**FINAL FINDINGS AND DECISION BY THE DESIGN
COMMISSION RENDERED ON August 15, 2013**

CASE FILE NUMBER: LU 13-147922 DZM AD
Janey II Apartments

Case Type: **DZM AD** (Design Review with Modifications and Adjustment)

GROUND LEVEL FLOOR PLAN

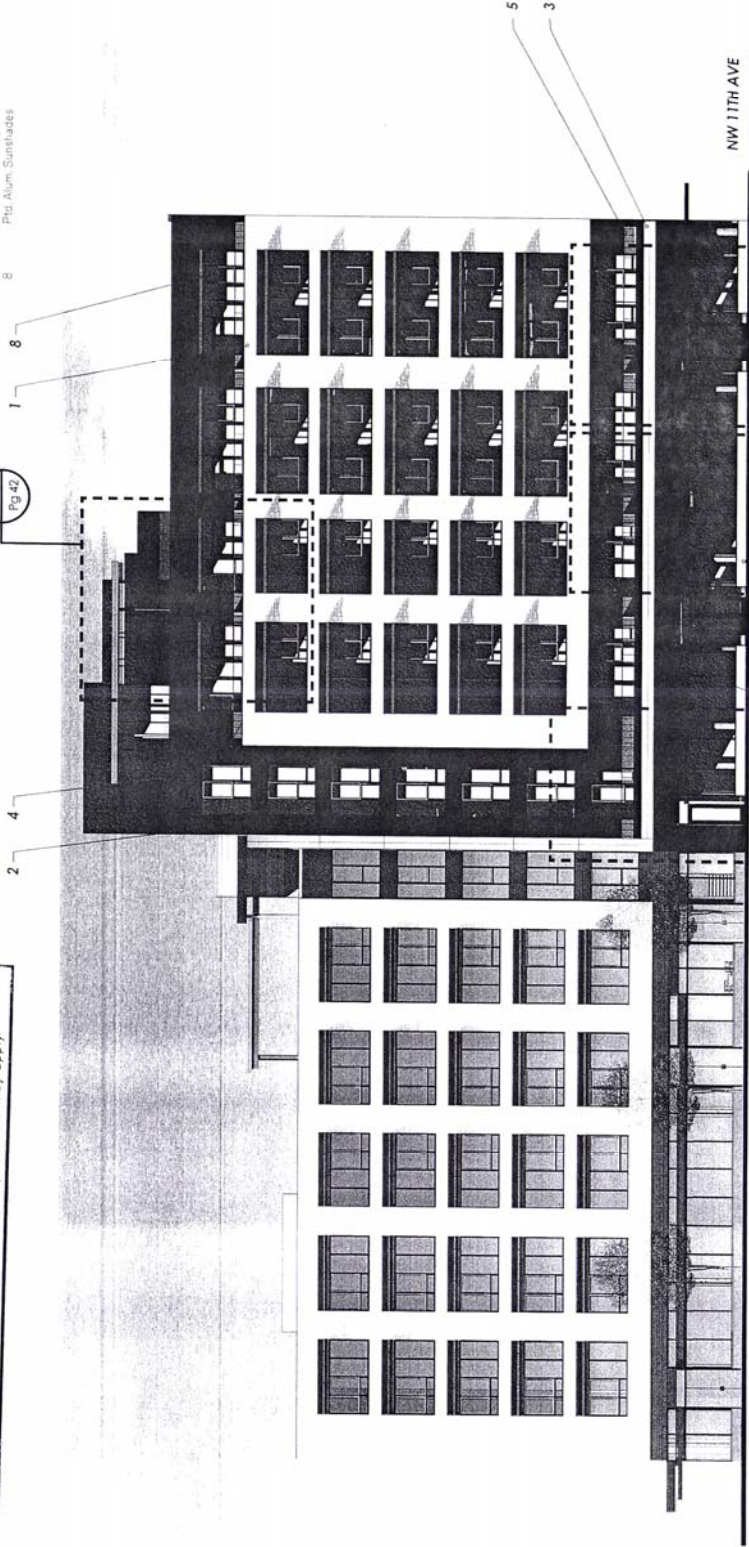
* Note - door location moved east after this drawing created

ELEVATION - NORTH - B&W

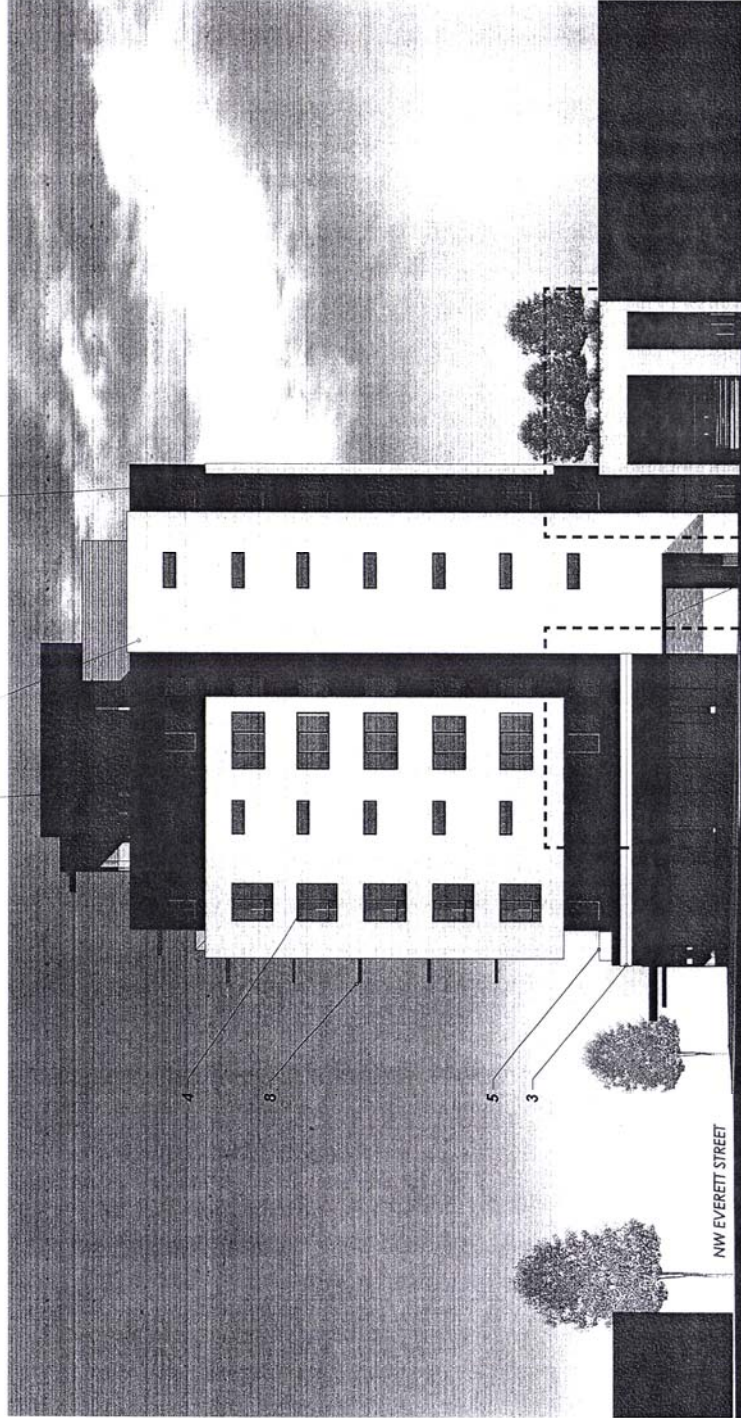
- B. The area surrounding the garage opening on 11th Avenue must be modified per the discussions at the final hearing, including matching width and header height for the windows on either side of the garage door, and the return of a buff brick surround in the area versus metal panel as originally proposed (**staff note:** the applicant has submitted revised east elevations and details for this final decision accurately reflecting the condition - notes are included on affected pages in the drawing set).

**FINAL VERSION FOR
DESIGN COMMISSION
CONDITION OF APPROVAL**
